**PLANNING COMMISSION MEETING**  
**Wednesday August 14, 2024**  
**7 PM**

**PLANNING REPORT**

Gravity Dance Studio has requested PUD Development Stage Site and Building Plan approval to allow the construction of a 9,176 square foot dance studio upon a 2.0-acre undeveloped site located southwest of the intersection of County Road 37 NE and County Road 19 NE. Specifically, the subject site occupies Lot 2, Block 1 of the Albertville Plaza 2<sup>nd</sup> Addition.

**SITE AND UTILITY PLAN**

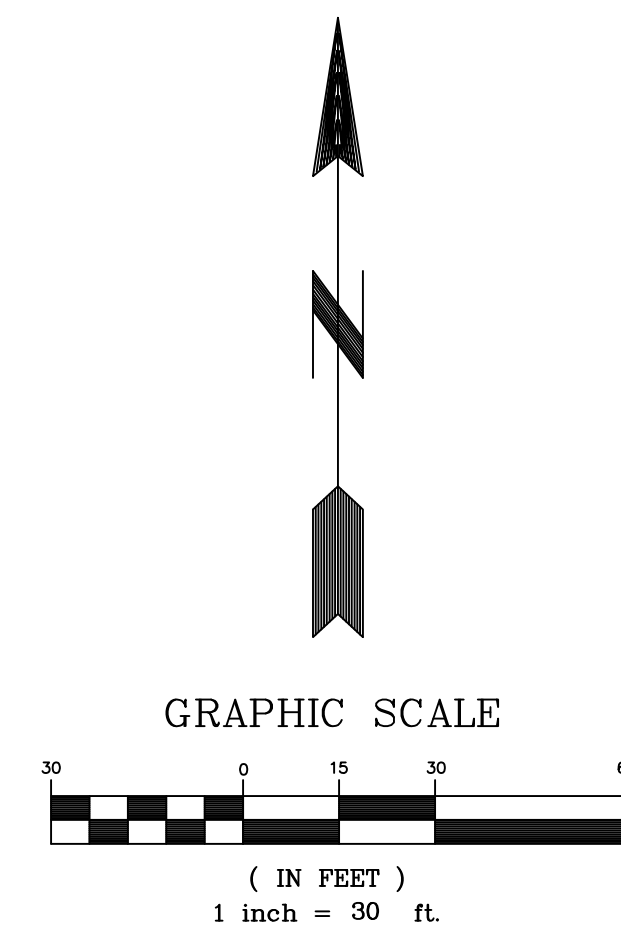
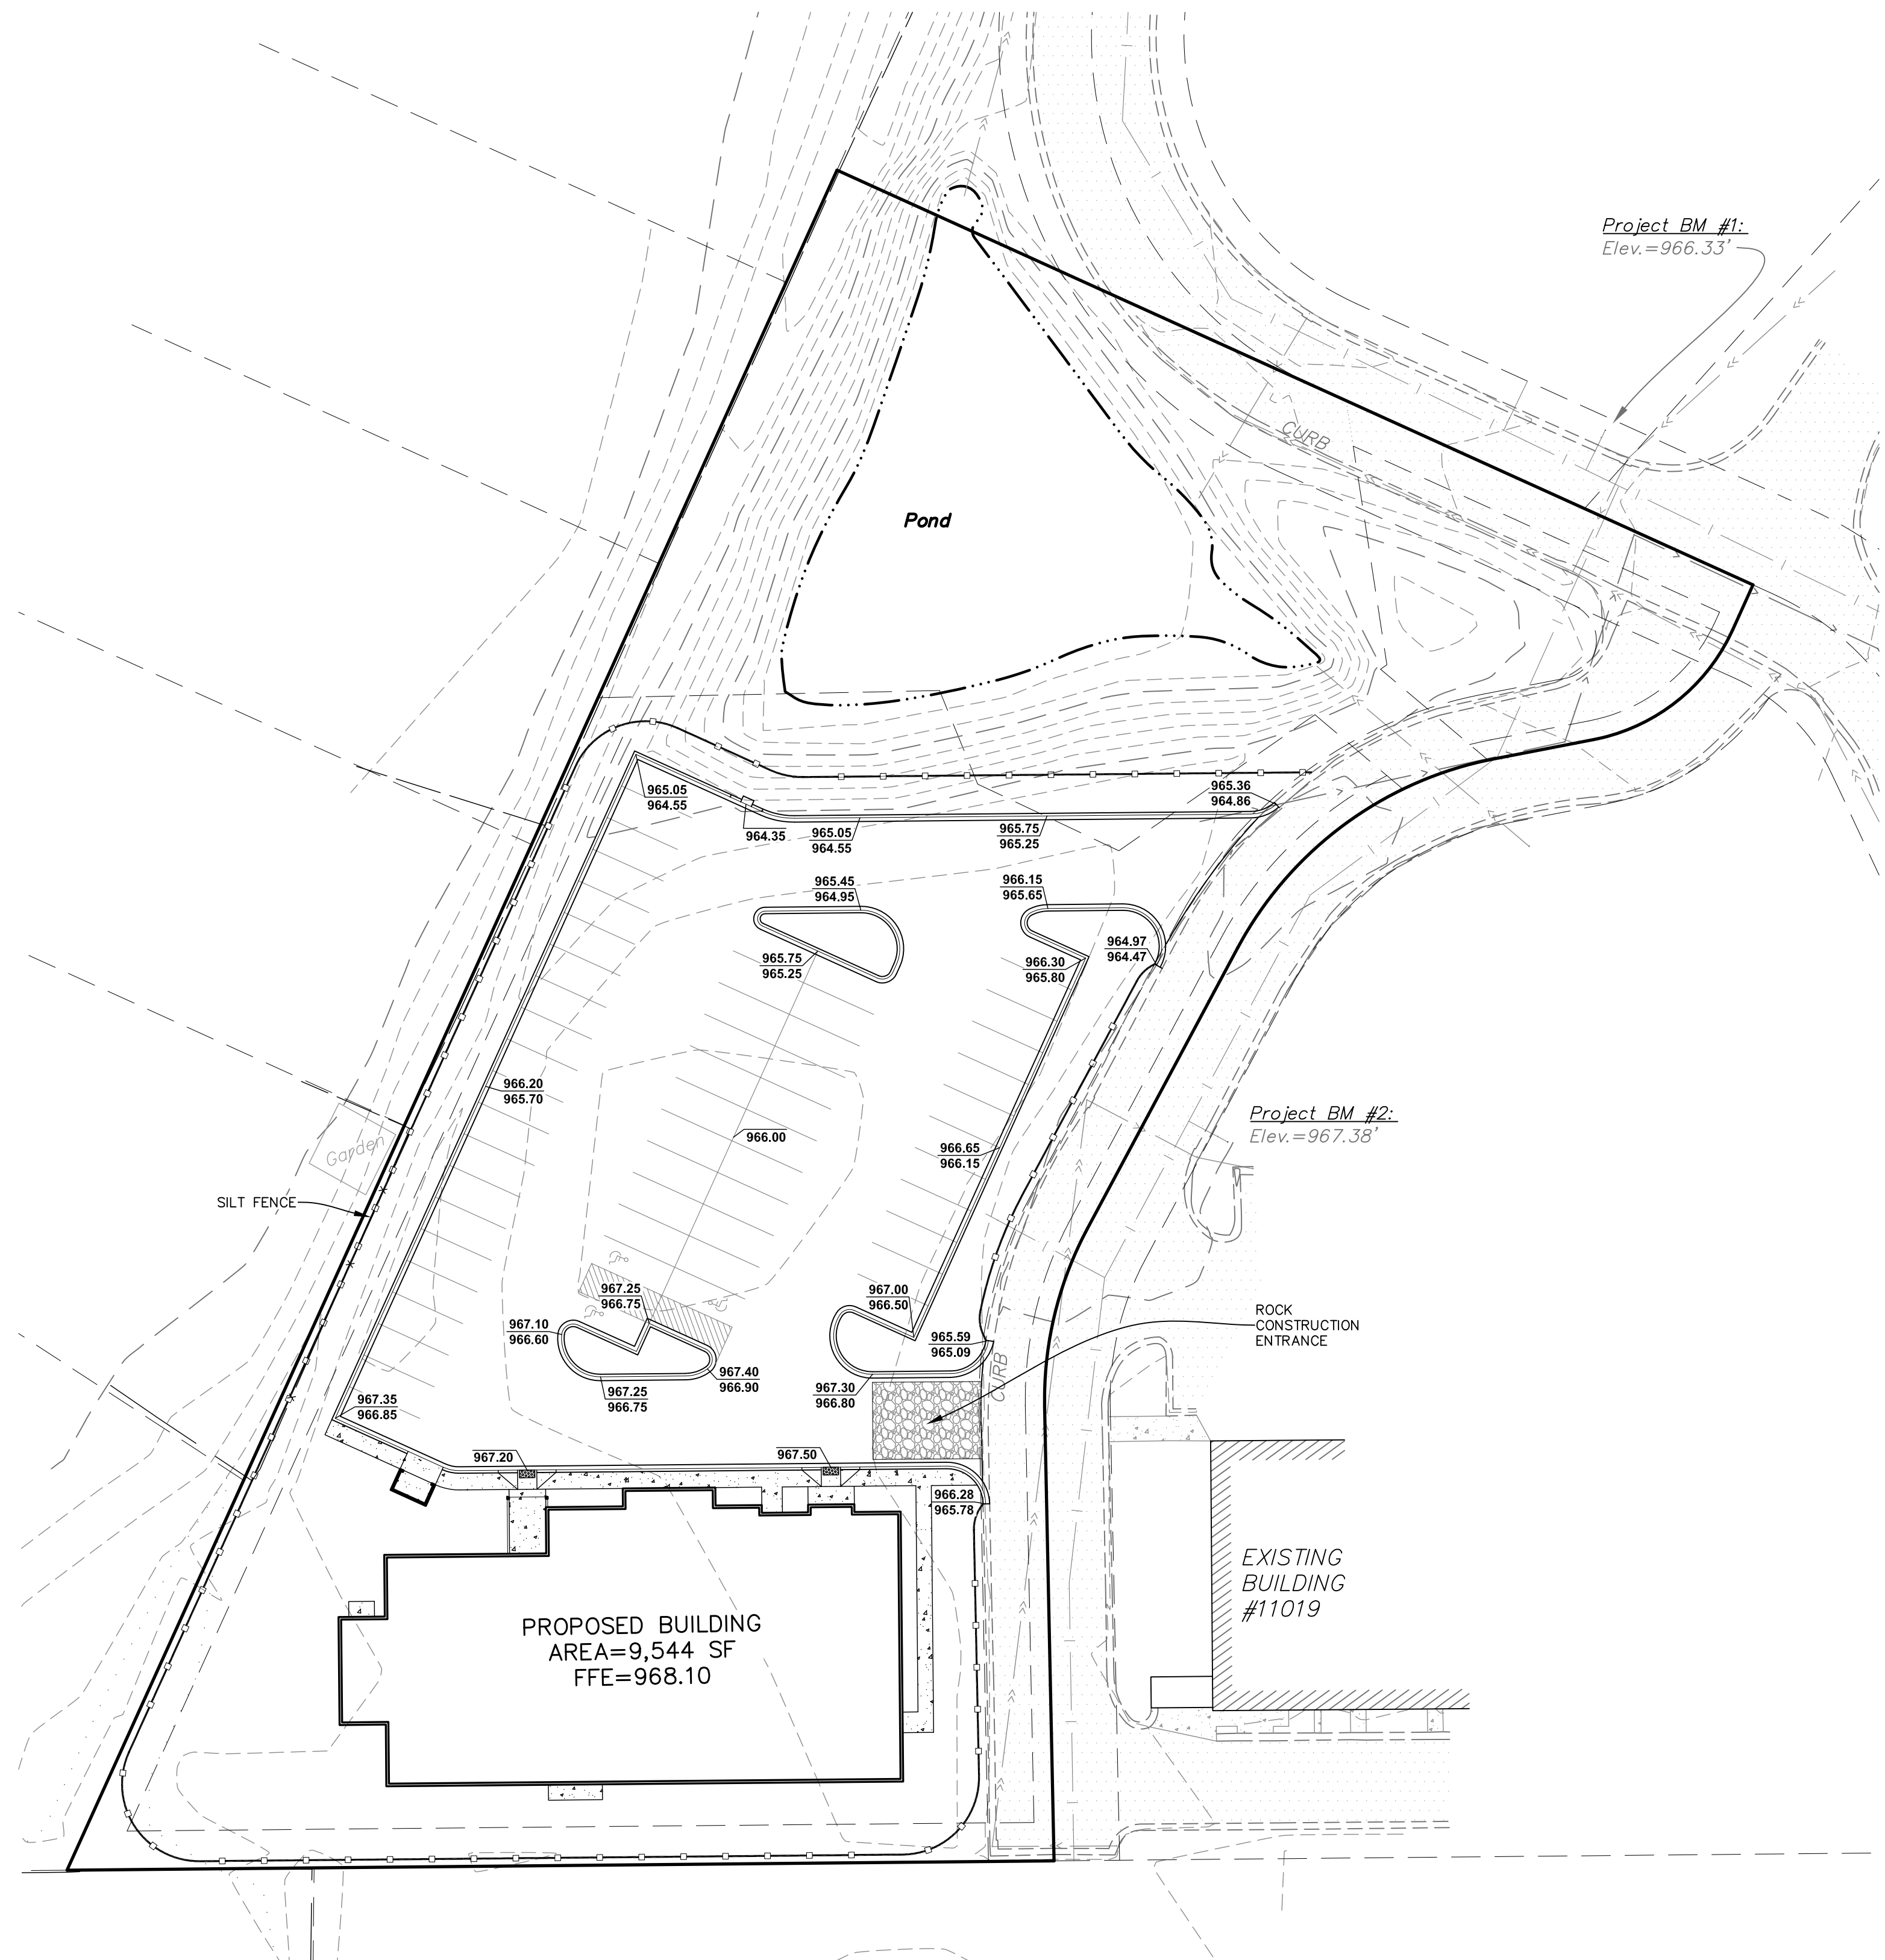
The submitted site plan illustrates 56 off-street parking stalls, three of which are accessible stalls. In addition, 10 “proof of parking” stalls are illustrated along the northern boundary of the parking lot. Thus, a maximum of 66 stalls can be available to accommodate the off-street parking demand generated by the proposed use. Based on the occupancy loads identified on the floor plan the 56 stalls will be

**Loading:** The proposed building will contain both the dance studio and another retail tenant space. As part of plan review, the site must have adequate area within the parking lot to accommodate turning maneuvers of oversized vehicles including garbage and delivery trucks.

While the curb cut locations and widths are considered acceptable for dance studio patron vehicles, some concern exists whether such width and related turning radii will be able to accommodate turning maneuvers of oversized service vehicles. As a condition of site and building plan approval, the applicant must demonstrate, to the satisfaction of the City, an ability to accommodate trash handling and delivery vehicles on the site by superimposing truck movements through the site plan.

**Trash:** As shown on the submitted site plan, a detached trash handling enclosure is proposed near the northwest corner of the dance studio building. The applicant shall be required to provide a detail of the trash enclosure demonstrating that its exterior finish materials match or complement the principal building.

**Utilities:** The provided utility plan has been superimposed on the submitted site plan. The utility plan shall be subject to review and approval by the City Engineer. The Utility plan must provide separate potable water and fire suppression services entering the building.

2. The site plan shall demonstrate truck turning movements to accommodate trash handling and delivery vehicles moving through the site.
3. The City retains the right to require the proof of parking stalls be constructed if parking occurs outside of approved parking stalls or on the private street.

4. Disability parking stalls shall include proper signage.
5. The applicant shall be required to provide a detail of the trash enclosure demonstrating that its exterior finish materials match or complement the principal building.

8. The utility plan shall be subject to review and approval by the City Engineer.
9. Applicant shall provide details on the exterior light fixture. All lights must be 90 degree cutoff fixtures with shielded light source to prevent glare toward the residential properties.
10. Freestanding light fixtures shall not exceed the maximum 30-foot height requirement of the Ordinance.
